**Pier 26 Upland Park Construction – Landscape and Irrigation
Project/Contract #C4891-D
Addendum # 3
December 3, 2018**

3. Attachment A of the RFP contained in the Project Manual is hereby amended as follows and as specifically set forth in Attachment 1 herein:

(A) "1. C4891 –A-E Pier_26 Upland Park Construction" is amended to include the following drawing modifications:

GRADING PLAN - PIER D

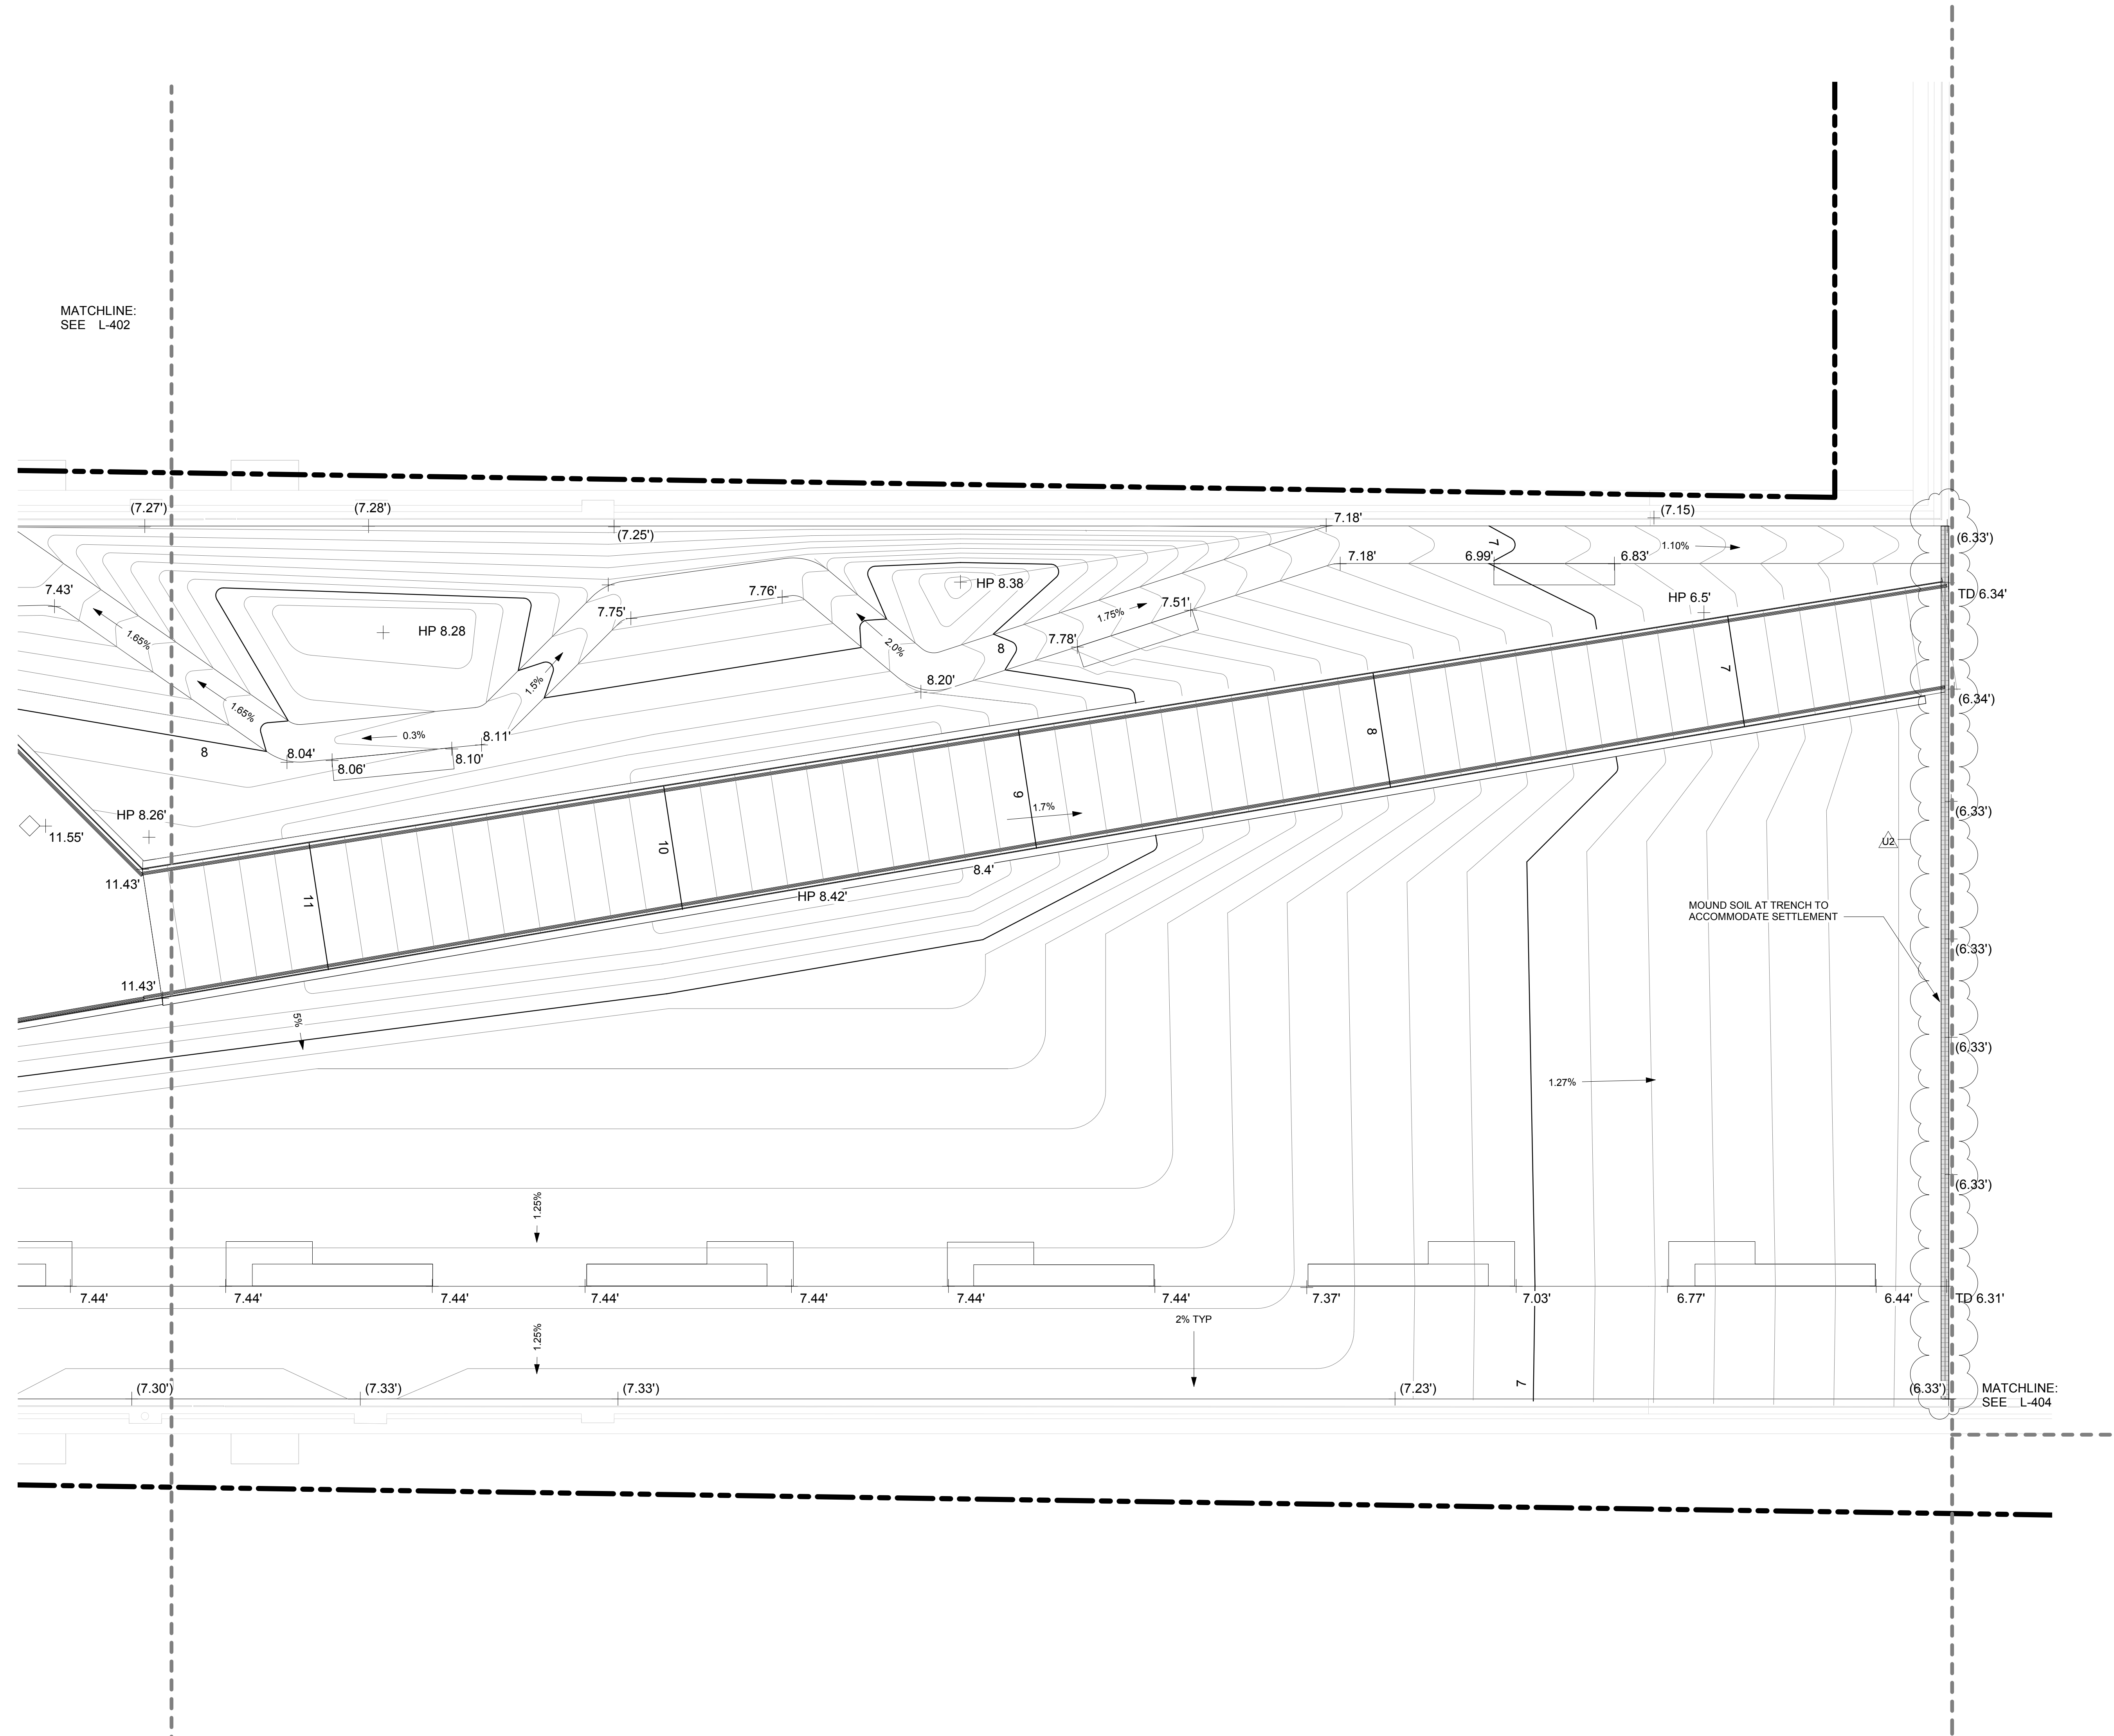
L-402 - GRADING PLAN - PIER C	Symbol for slot drain and trench drain has increased visibility.
L-403 - GRADING PLAN - PIER D	Symbol for slot drain and trench drain has increased visibility.
L-404 - GRADING PLAN - NORTH UPLAND	Symbol for slot drain and trench drain has increased visibility.
S-301 - FRAMING PLAN - PIER B	Walkway south of seating terrace no longer called out as 8" concrete seating step.
S-302 - FRAMING PLAN - PIER C	The thickness of the concrete is correctly labeled to show the 8" depth only at the 15' wide southern, as in the materials plans.
E-301 - ELECTRICAL PLAN - PIER B	Location of Q-vault shown.
E-302-ELECTRICAL PLAN - PIER C	Electrical clarification to sport pole.
E-308 - WOOD AND STEEL SHED ELECTRICAL DETAILS.pdf	New sheet showing clarifications of electrical work at the sheds.
P-303 - SANITARY PIPING PLAN - PIER D	Cross section of piping added.
P-312 - SANITARY PIPING PLAN - PIER C	Clarification to boat service utilities.
